Review of HSL QRA for proposed LNG terminal

Proposed solution for Gib Elec LNG terminal

Technical note for:
Gibraltar Electricity Authority

Technical note no: 105913-2/TN-1 Rev: A

Figure 2.2 - Risk picture (3 zone map) developed by HSL for Shell's proposed sensitivity

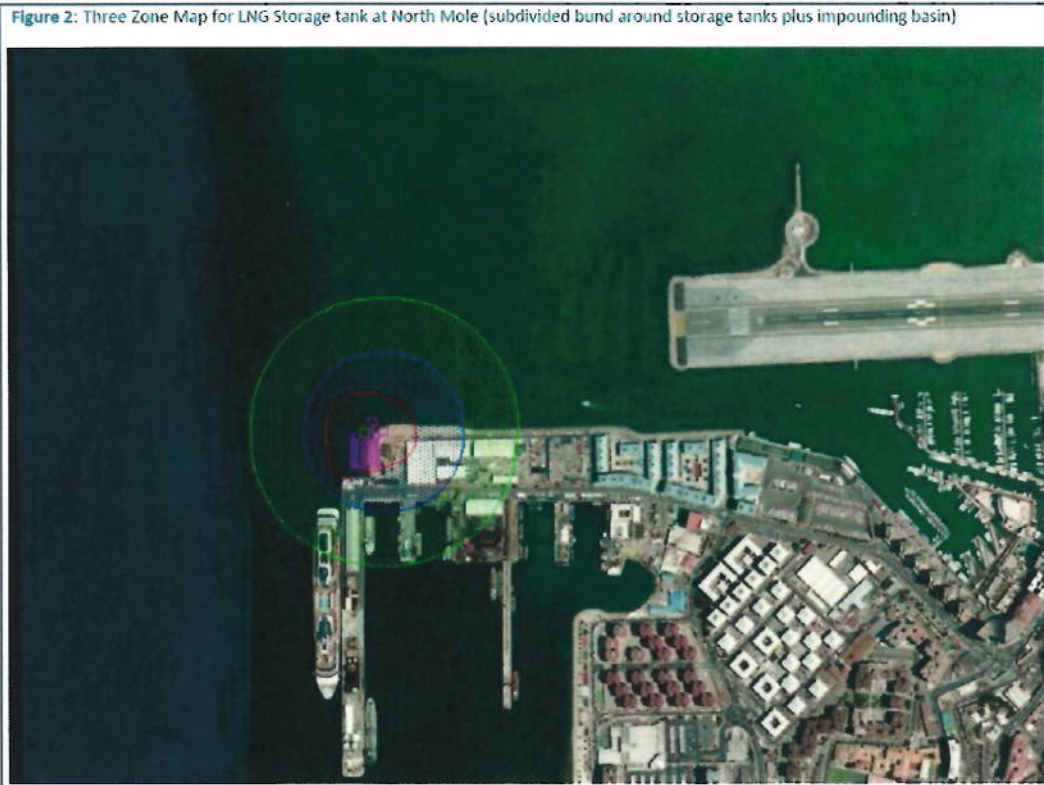
This design reduces the extent of all three zones and in particular the two inner zones. This seems to be a good risk reducing measure.

GEA has per mail to Lloyd's Register confirmed that *"I can confirm that the GEA preferred option is to subdivide the bund as this has been demonstrated by Shell to reduce the risk contour maps"*, Ref. /4/.
